Concerns regarding the Sunnyside Renewable Natural Gas (SS RNG) Biodigester

FOTC presumes that the “reception pits” are labeled “feeding” in Figure 4, copied below with “feeding” circled in red.

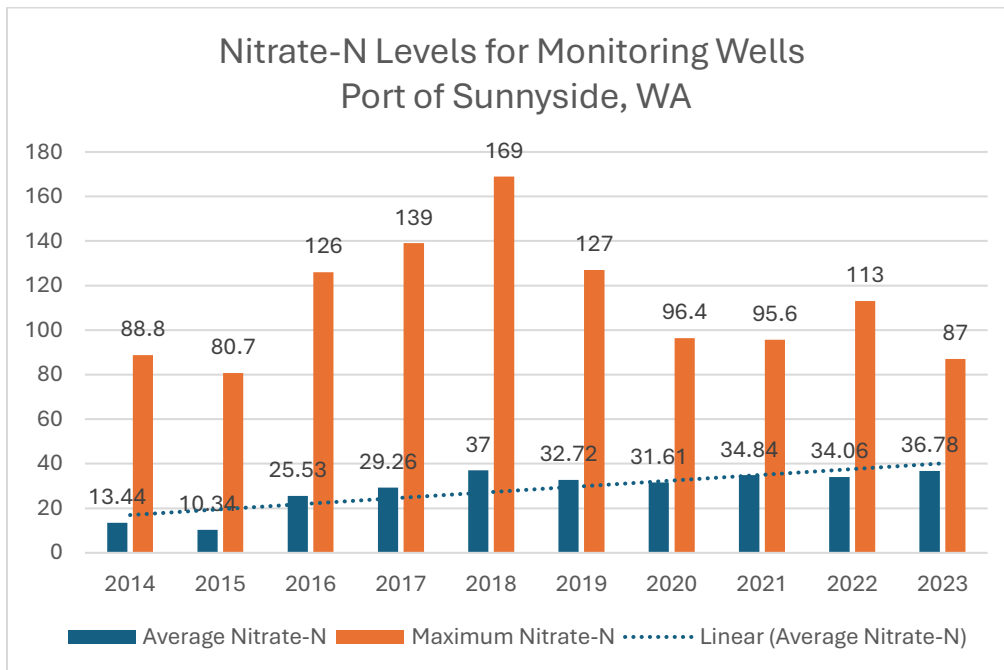
The “reception pits” are not identified as emission sources. There are zero estimates of emissions from “reception pits” or from pumping activities related to mixing tanks.

No emissions from “reception pits” or “mixing tanks” are listed in Table 1, page 14/131 of the Supporting Document. Receptor pits are not listed as authorized emission units in Table 2 on page 14/46 of the Order of Approval.

Attachment 5: Emission Point 6

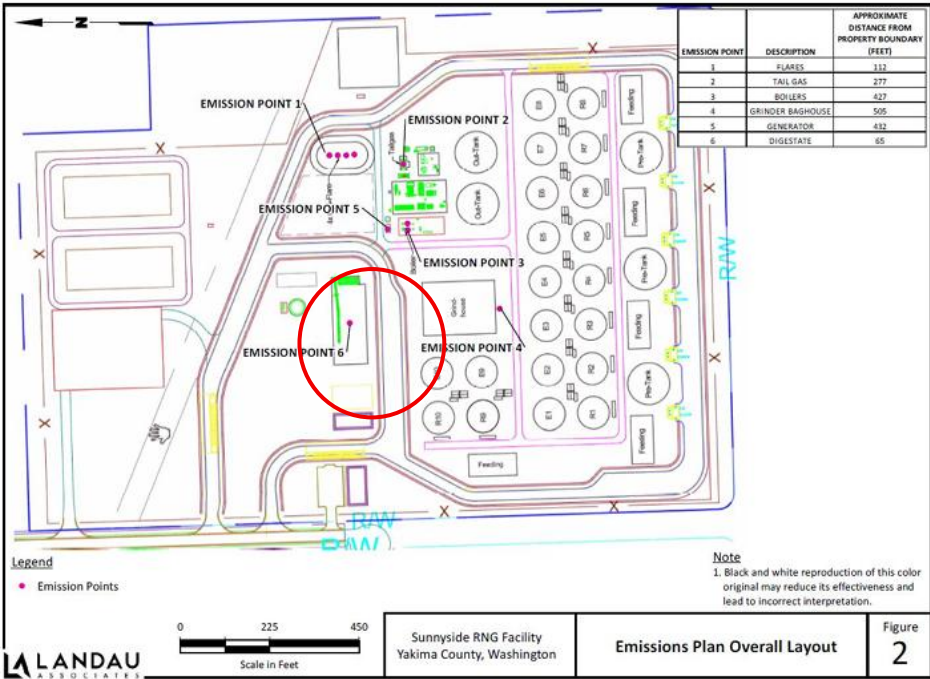
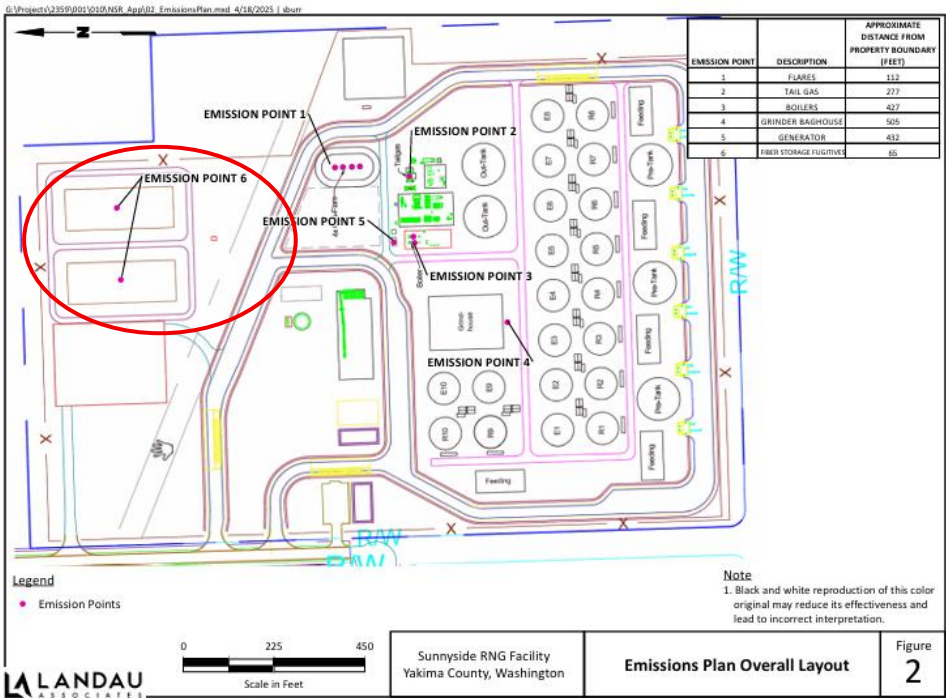
These figures do not agree on the location of Emission Point 6.
